Product/Process Change Notification (PCN)

Allegro is discontinuing its legacy UA 3-pin single inline package (SIP) as we invest in our next generation UA SIP featuring advancements in assembly technology, a matrix high density (HD) leadframe, and state of the art mold compound. Please take note of the minor dimensional and material changes.

Legacy UA vs Matrix HD UA - Visual Differences

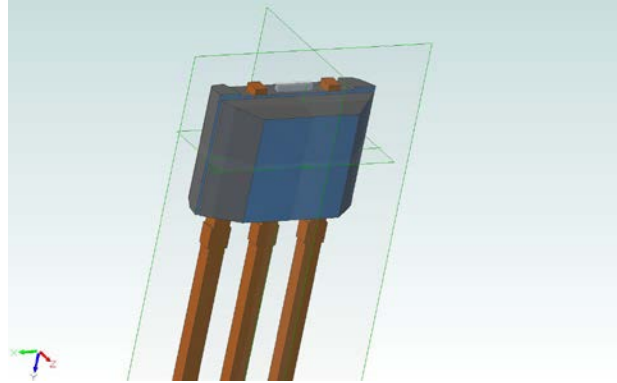
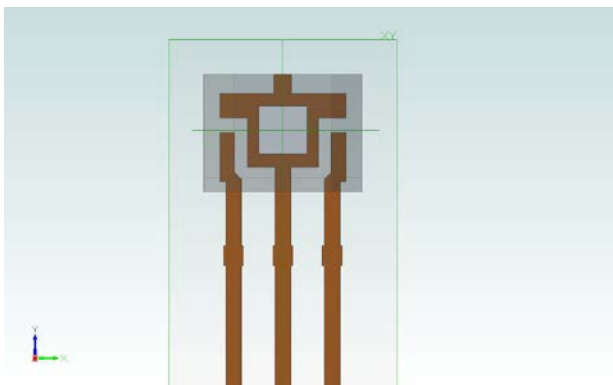
- Top of package on the Matrix HD UA has tie and dam bar protrusions

Legacy UA vs Matrix HD UA – Leadframe Differences

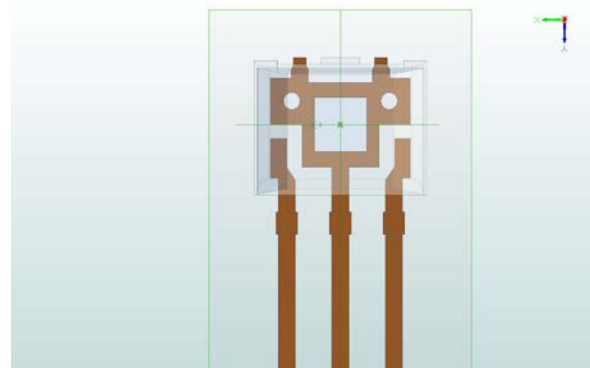
Lead Finish: Trim before Tin plate resulting in plating of the dambar with no exposed Cu

Dam bar from package: 1.02 mm

Legacy UA vs Matrix HD UA – Dimensional Comparison

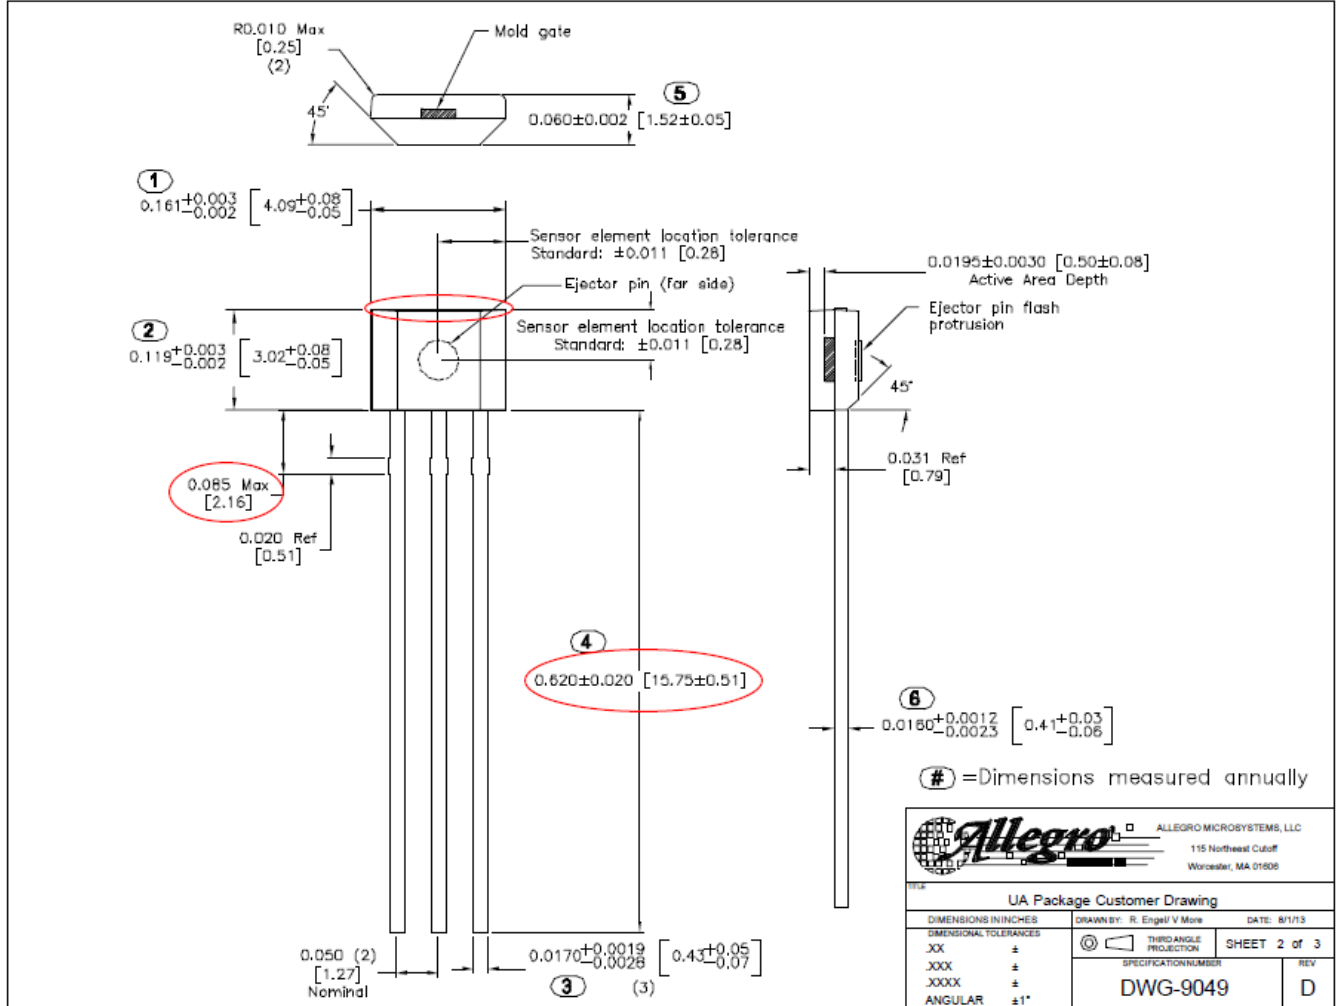
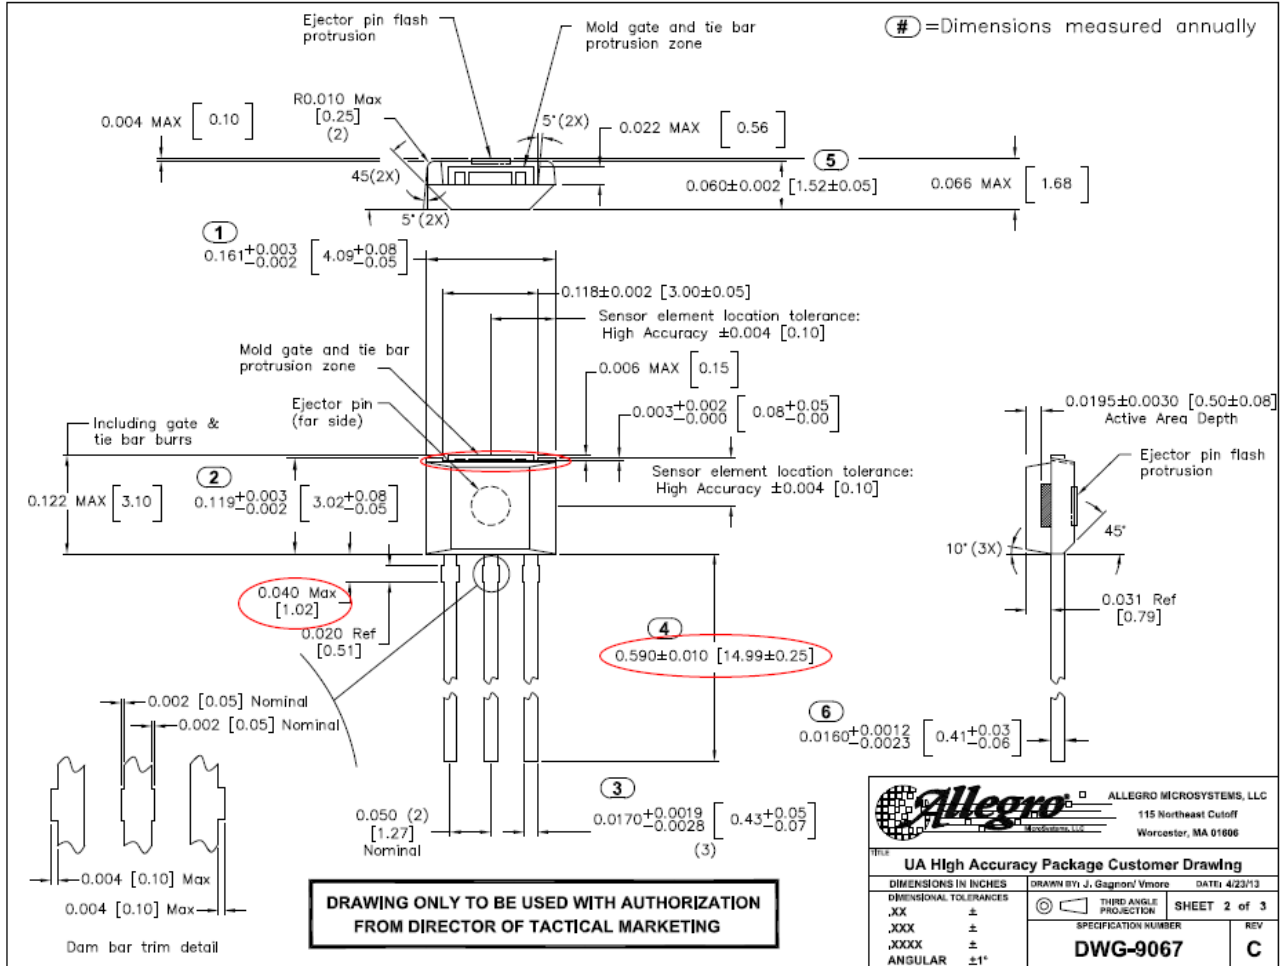
Package	Width (mm)	Height (including tie & gate bar protrusions) (mm)	Lead Length (mm)	Leadframe Mold Offset (mm)
Legacy UA	4.09 (+0.08, -0.05)	3.02 (+0.08, -0.05)	15.75 +/-0.51	+/-0.101
Matrix HD UA	4.09 (+0.08, -0.05)	3.02 (+0.08, -0.05)	14.99 +/-0.25	+/-0.051
